CHAPTER 9. CLARIFICATIONS AND REVISIONS TO THE DRAFT EIR

9.1 Introduction

9.2 Clarifications and Revisions

Figure 2.4-1. Existing Site Plan

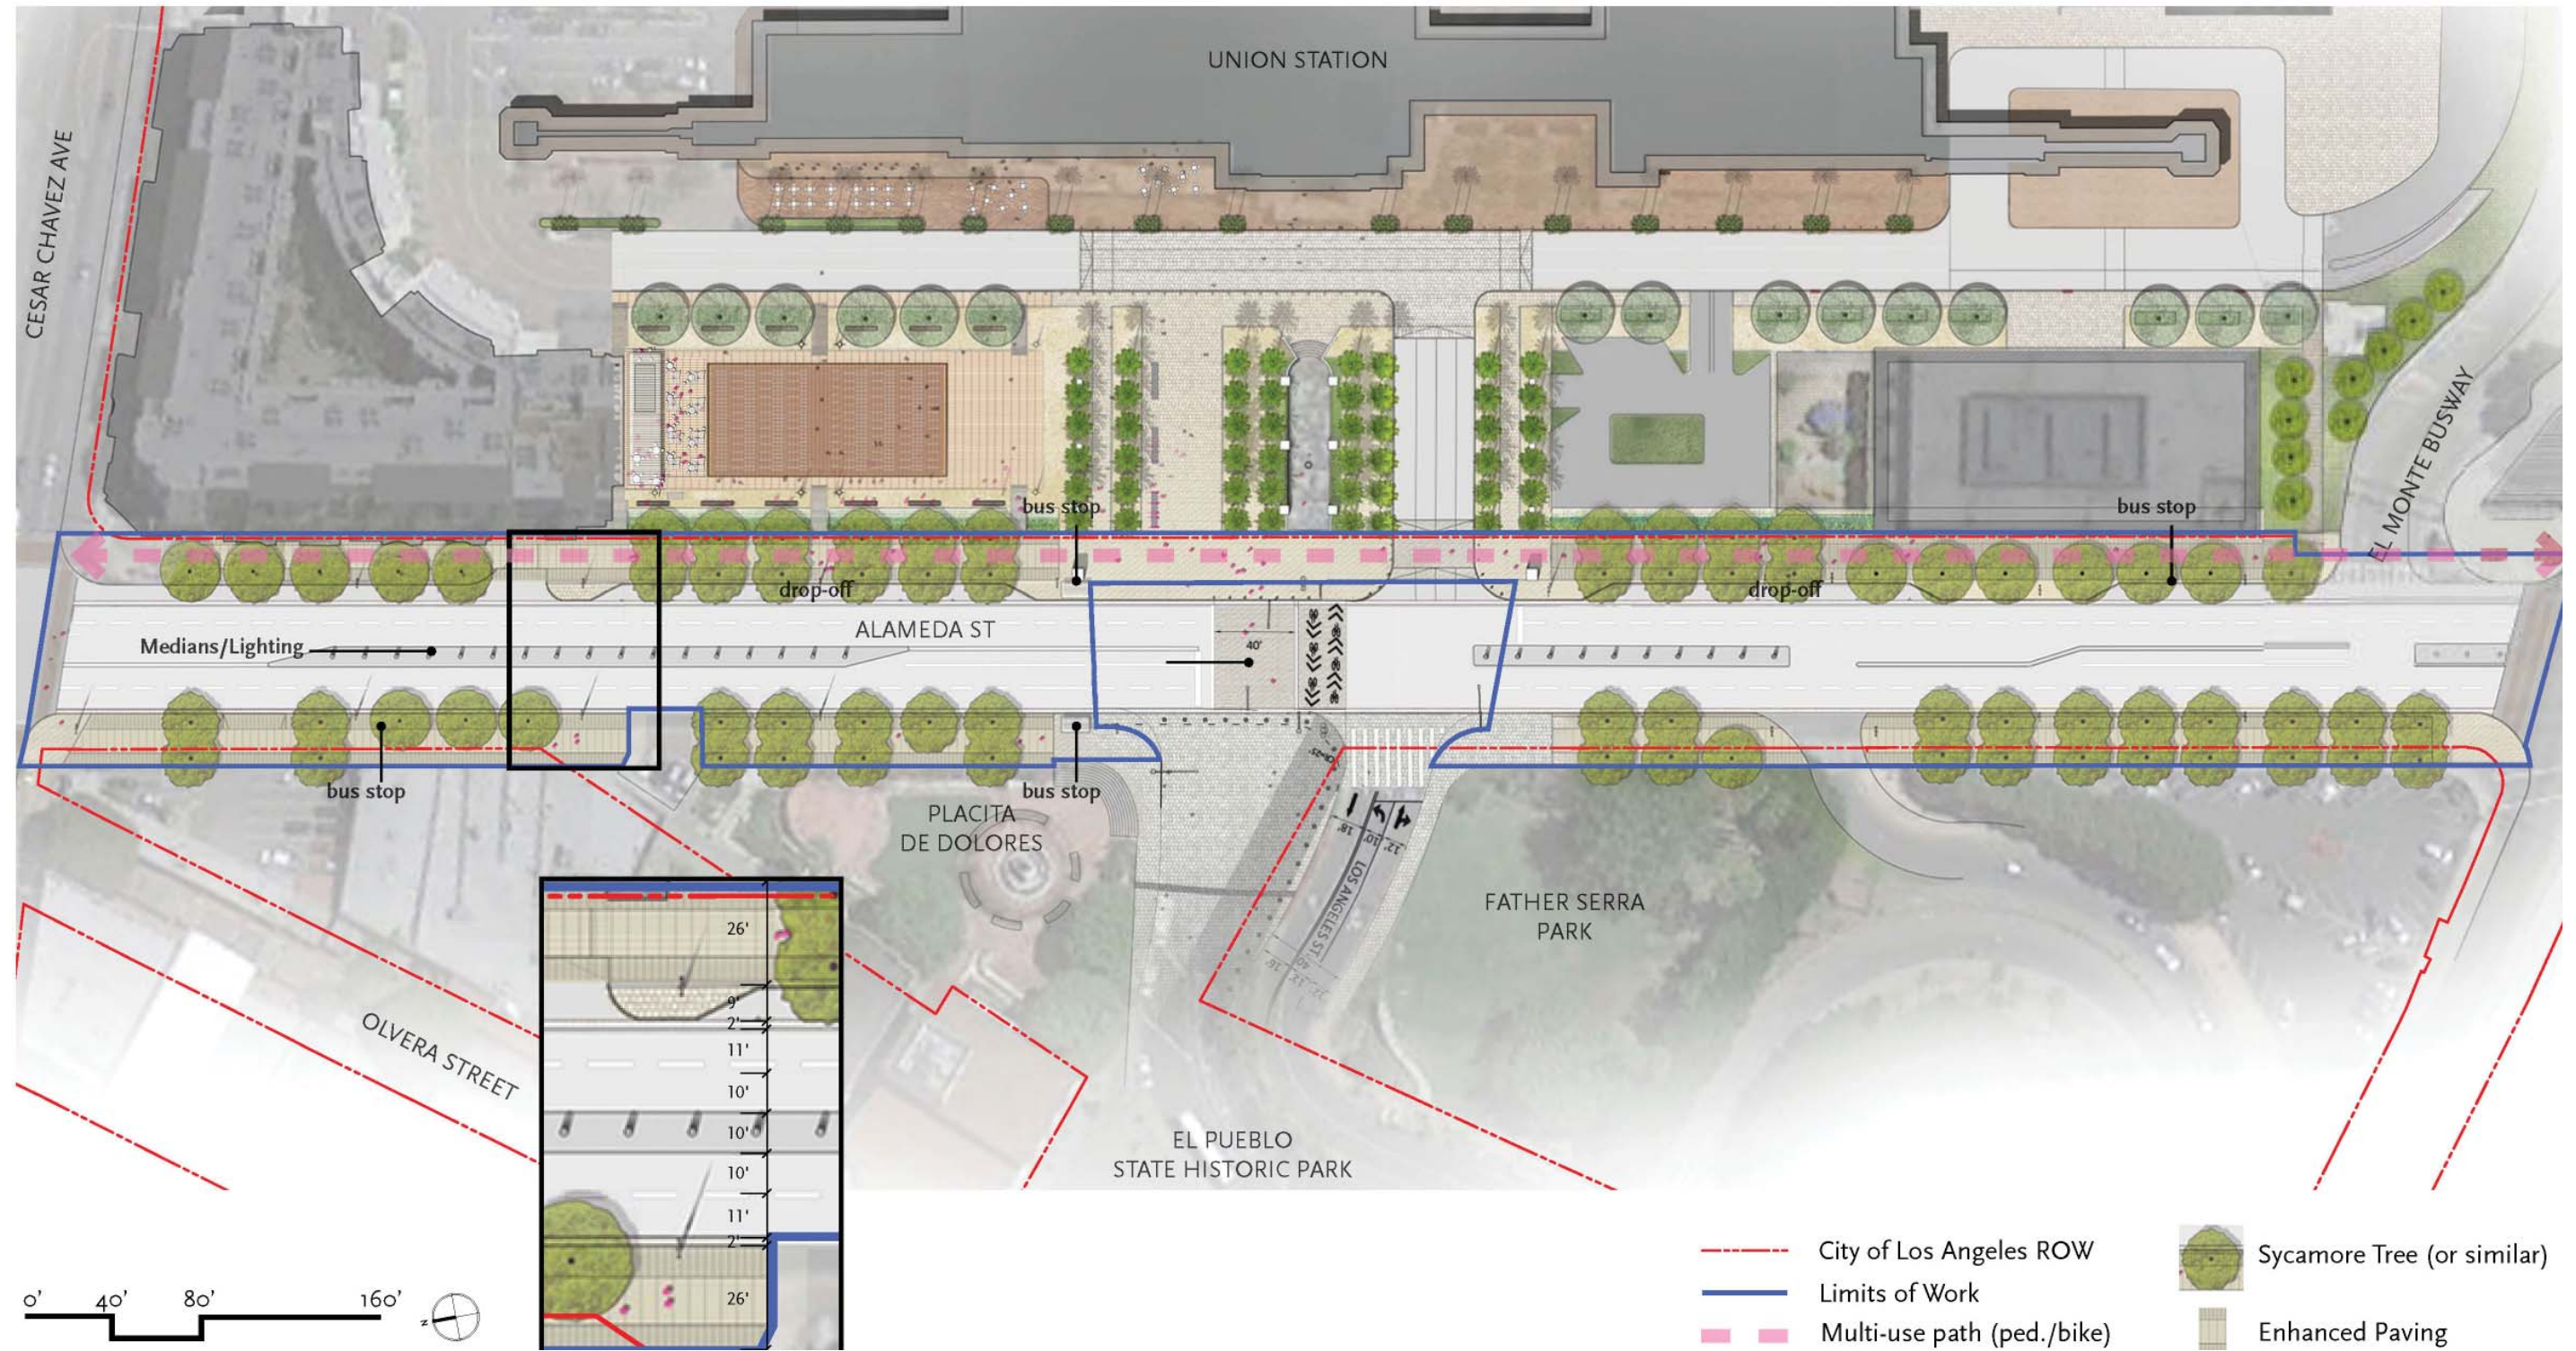
Page 2-6: Figure 2.4-1, *Existing Site Plan*, following this page, has been revised to show the dimensions of the existing buffered bicycle lane.

Page 2-6: Figure 2.4-2, *Project Plan*, following this page, has been revised to include a callout to the buffered bike lane.

Page 2-6: A new figure, Figure 2.4-3, *Alameda Street Improvements*, following this page, has been added to provide clarity on the project elements along Alameda Street.

Figure 2.4-4. Arcadia Street

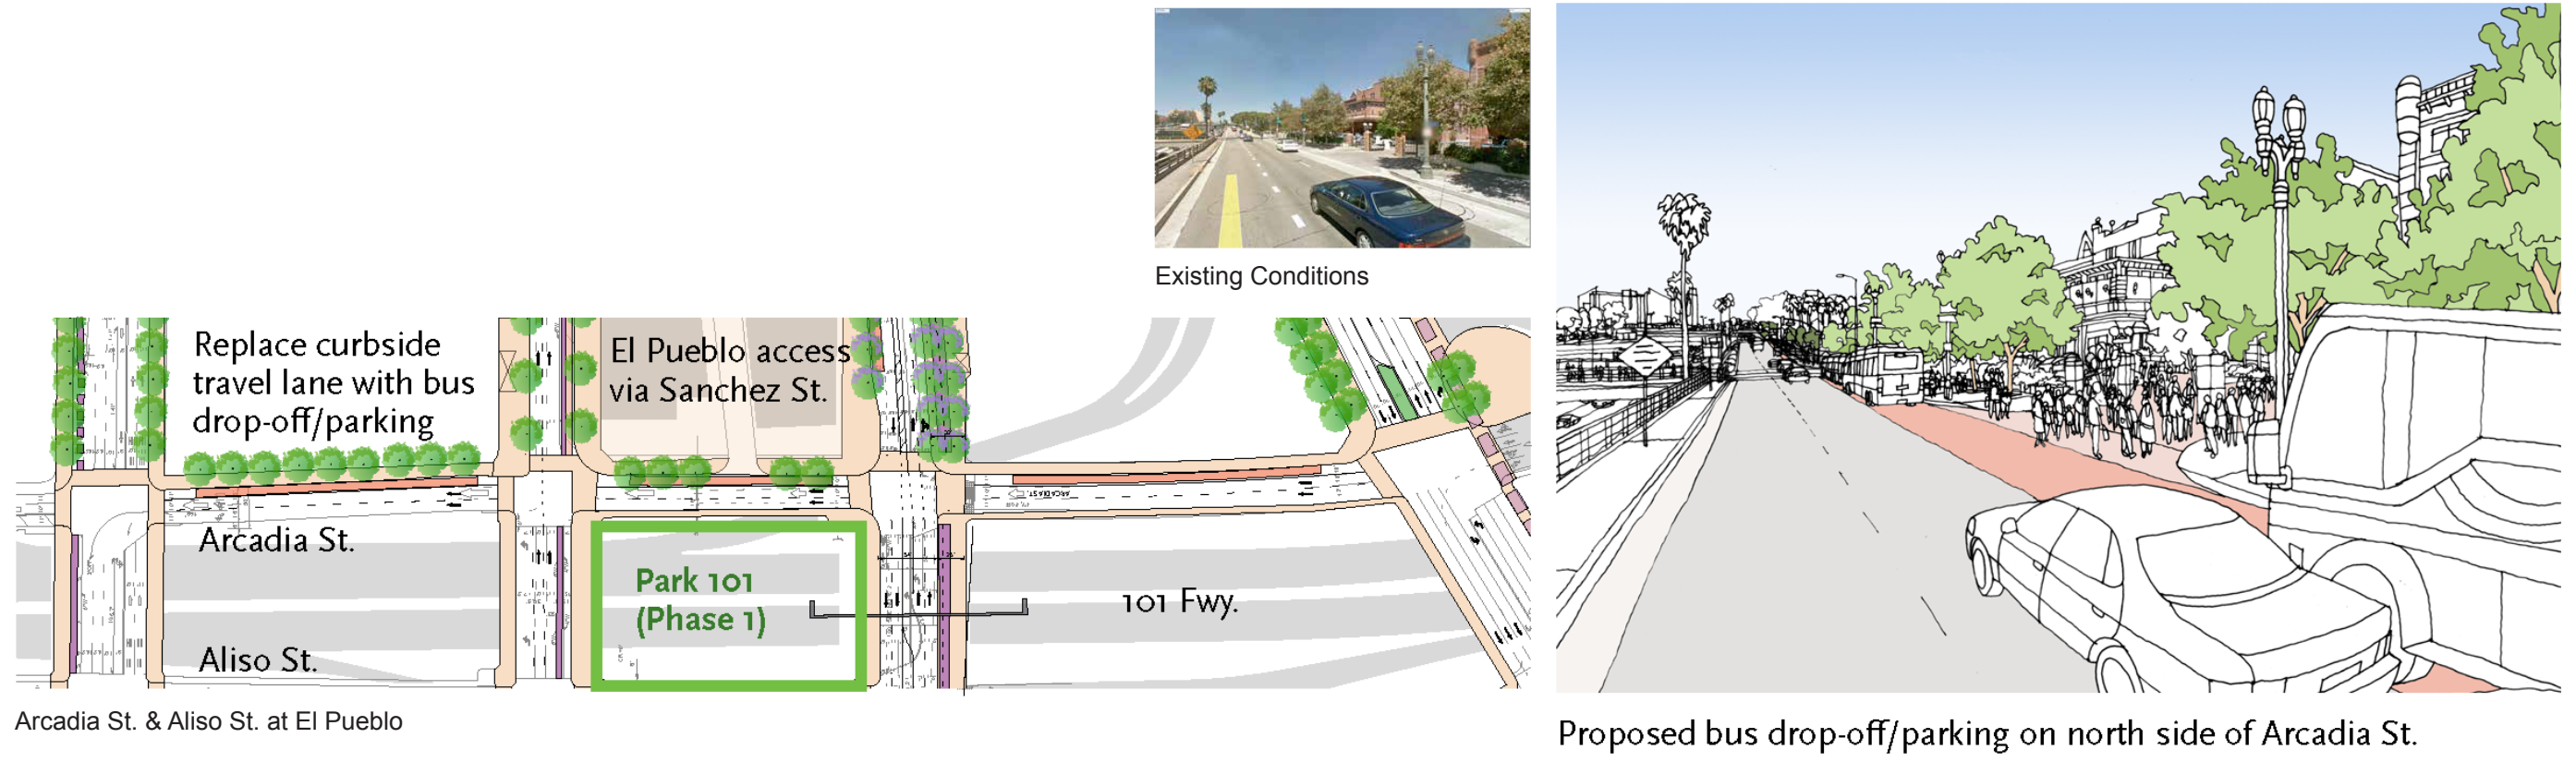
Page 2-8: A new figure, Figure 2.4-4, *Arcadia Street*, following this page, has been added to provide clarity on the project elements along Arcadia Street.

Figure 4.1.2-1. Alternative 2 Plan

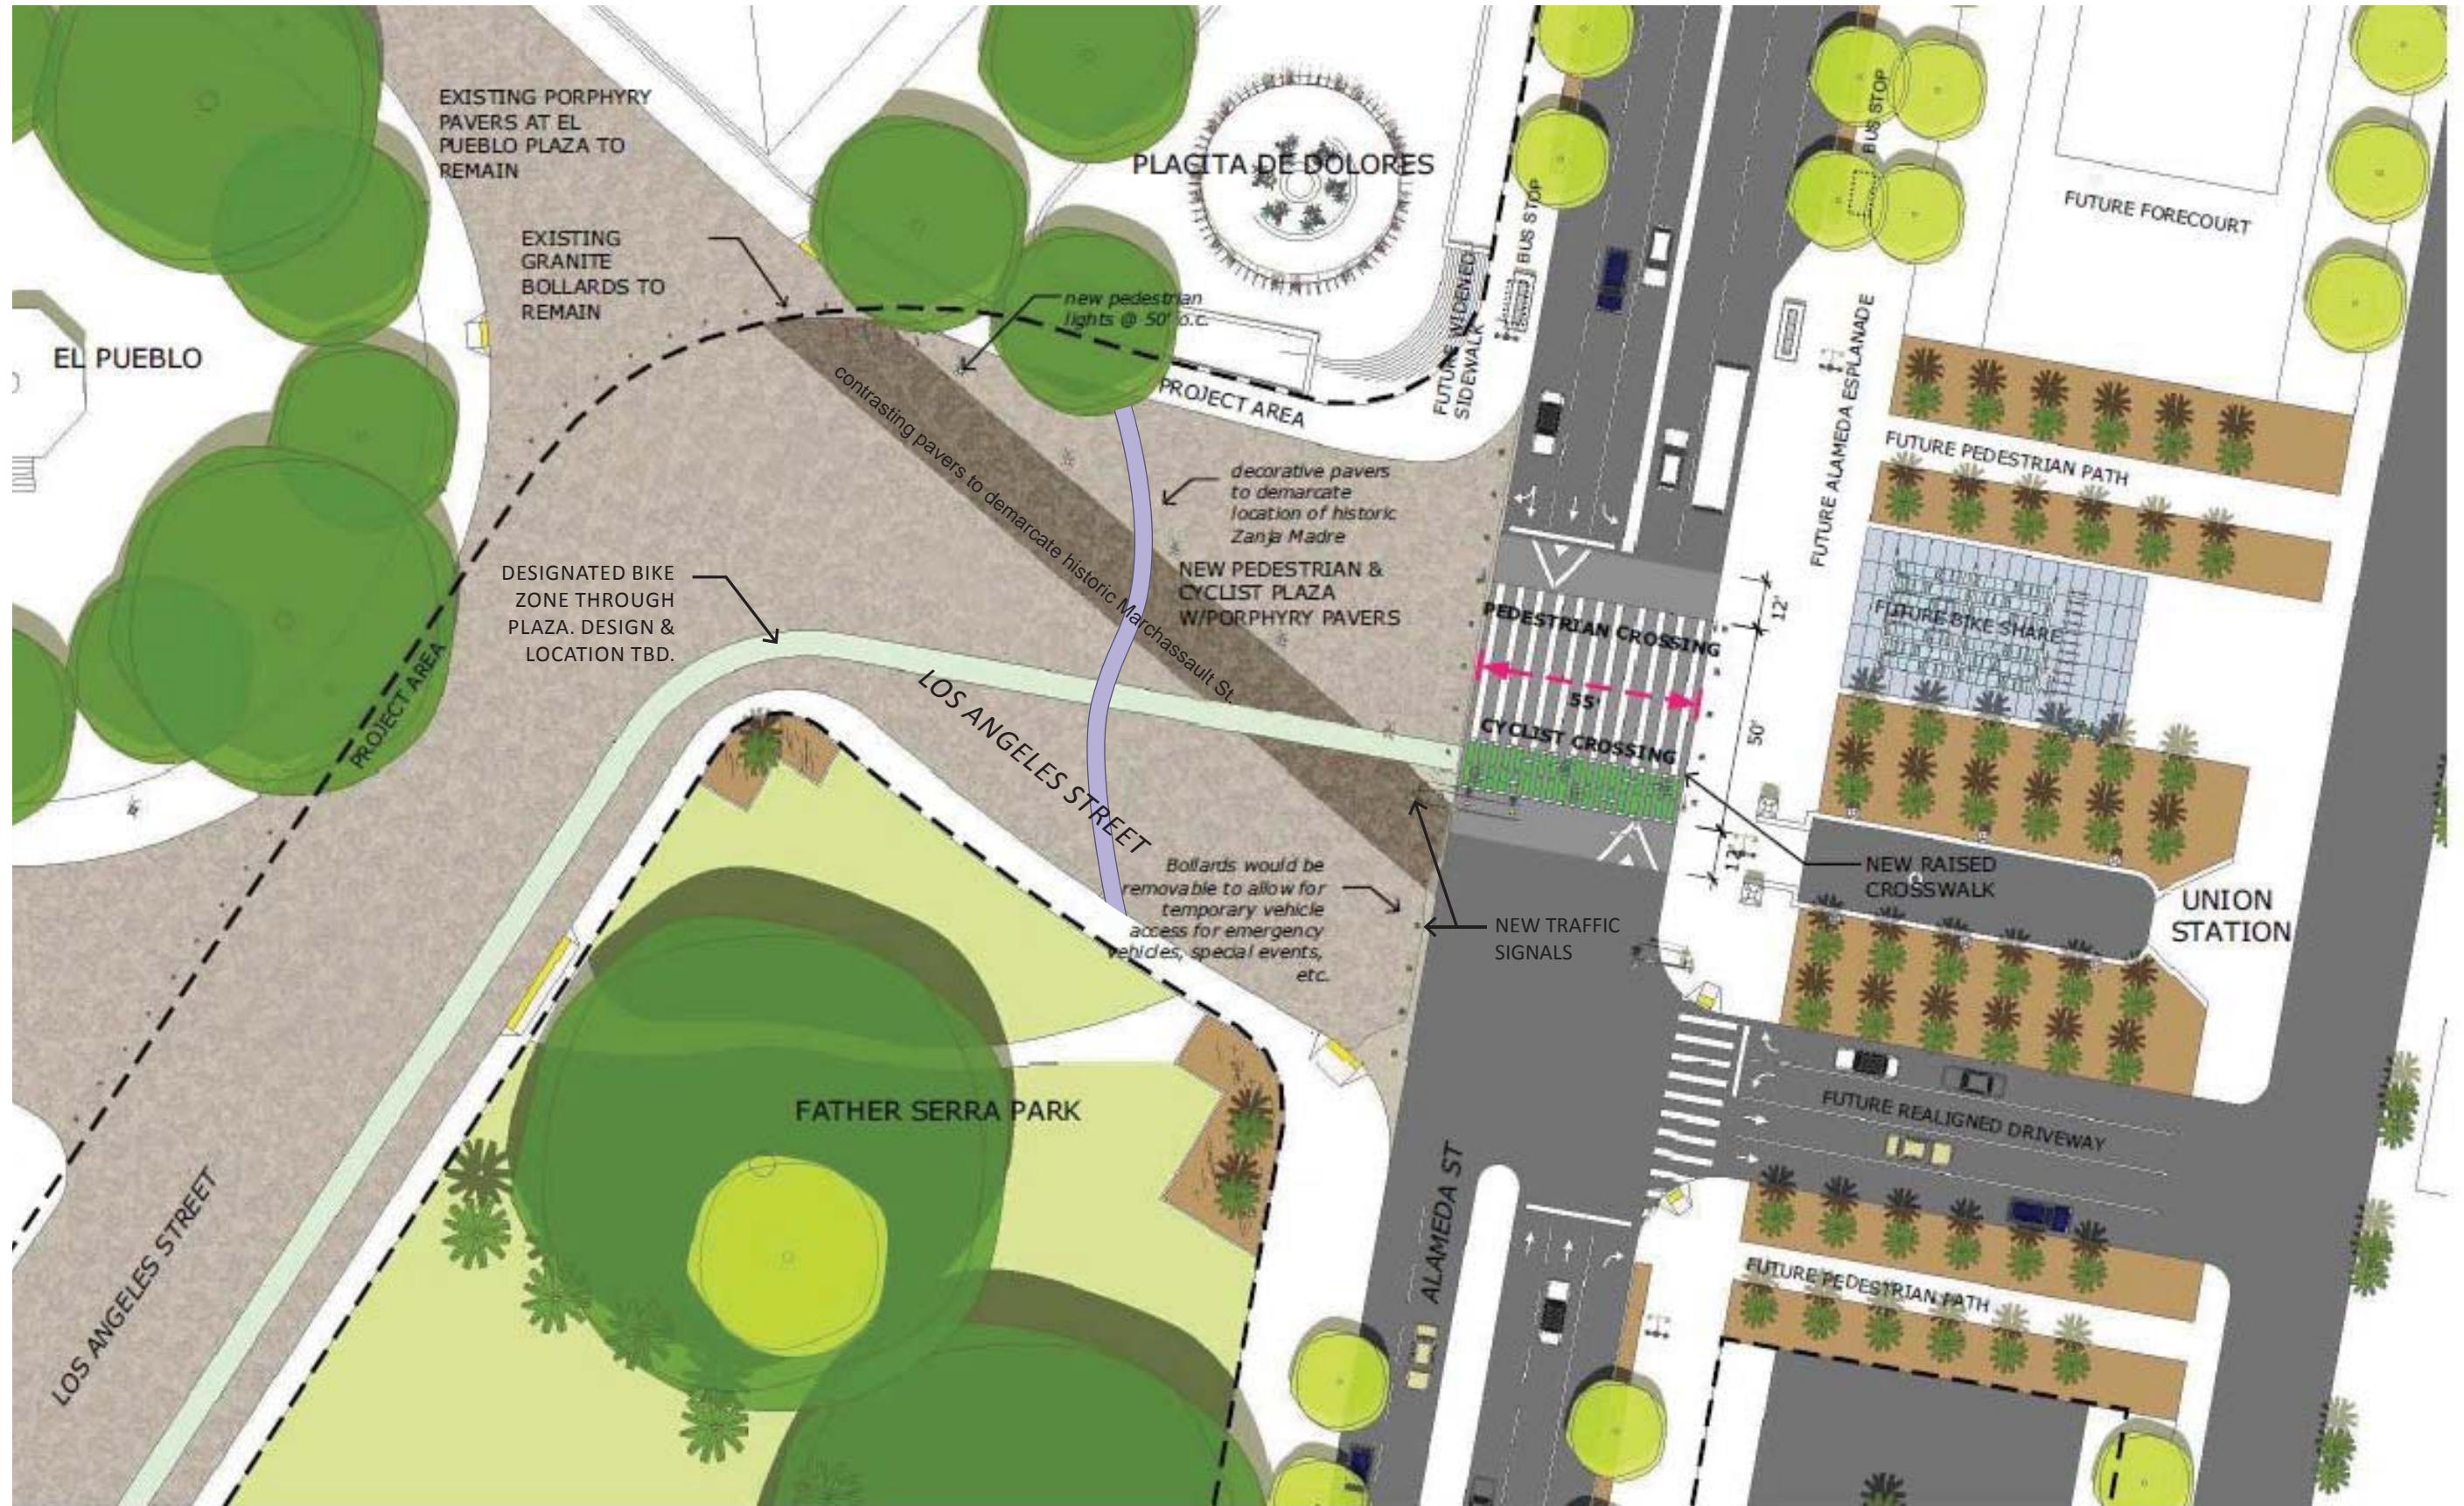
Page 4-2: Figure 4.1.2-1, *Alternative 2 Plan*, following this page, has been revised to include a callout to a designated bike zone through the plaza. Also, the figure has been revised to remove callouts on Los Angeles Street for the bus drop-off, continental crosswalk, and bollards within the plaza, which would not be used under the full closure of Los Angeles Street.

Page 4-2: Figure 4.1.3-1, *Alternative 3 Plan*, following this page, has been revised to include a two way, off street bicycle path within the expanded El Pueblo plaza near the west side of Los Angeles Street.
